Access Compliance Report Public Rights-of-Way (Curb Ramps)

Main Street: SKYWAY_DR		Cross Street: SE_SKYLINE_DR		Location:	NE
ADA ID: RPRK211012115430	Ramp Type: Type 7 - Directional 2	Initial Pass/Fail: Fail	Overall Compliance: No	Severity Score:	15
Codes/Mitigation Info/Possible Solution			Field Measurements/Component Compliance

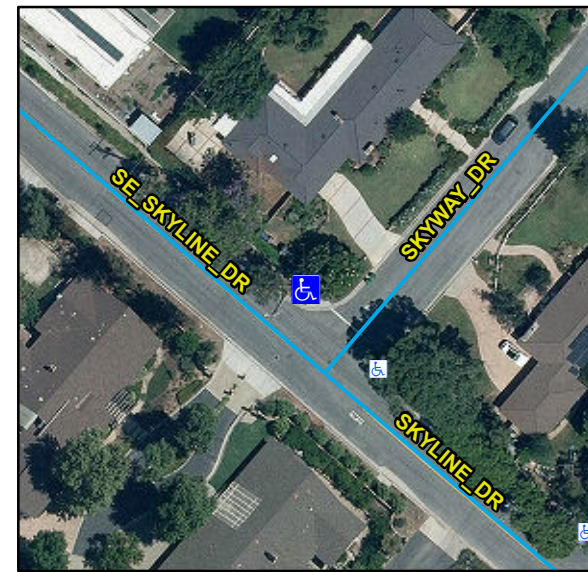
Compliance	Description	Data	Compliance	Description	Data
N/A	Ramp Length (in)	119	N/A	Flare Type LT	
Yes	Ramp Width (in)	95			N/A
No	Ramp Run Slope (%)	8.4	N/A	Flare Slope LT (%)	N/A
Yes	Ramp Cross Slope (%)	0.3	N/A	Flare Traversable LT	N/A
N/A	Grade Break	N/A	N/A	Flare Type RT	
N/A	Grade Break Slope (%)	N/A			N/A
N/A	Grade Break Cross Slope (%)	N/A	N/A	Flare Slope RT (%)	N/A
	Addl Para Ramp Left?	No	N/A	Flare Traversable RT	N/A
	Addl Para Ramp Right?	No	N/A	DWS Provided	N/A
N/A	Landing Present	N/A	N/A	DWS Contrast	N/A
N/A	Landing Length (in)	N/A	N/A	DWS Length (in)	N/A
N/A	Landing Width (in)	N/A	N/A	DWS Full Width	N/A
N/A	Landing Run Slope (%)	N/A		DWS Offset Type	N/A
N/A	Landing Cross Slope (%)	N/A	N/A	DWS Left Offset (in)	N/A
N/A	Landing Movement Obstructed?	N/A	N/A	DWS Right Offset (in)	N/A
	Landing Movement Type	N/A			
N/A	Landing Shared	N/A			
N/A	Marked Crosswalk 1	No	N/A	Clear Space	N/A
	Crossing 1 Direction	SE	N/A	Clear Space To Crosswalk (in)	N/A

Remove & Replace Entire Ramp.

R304.2.2, STD 1115
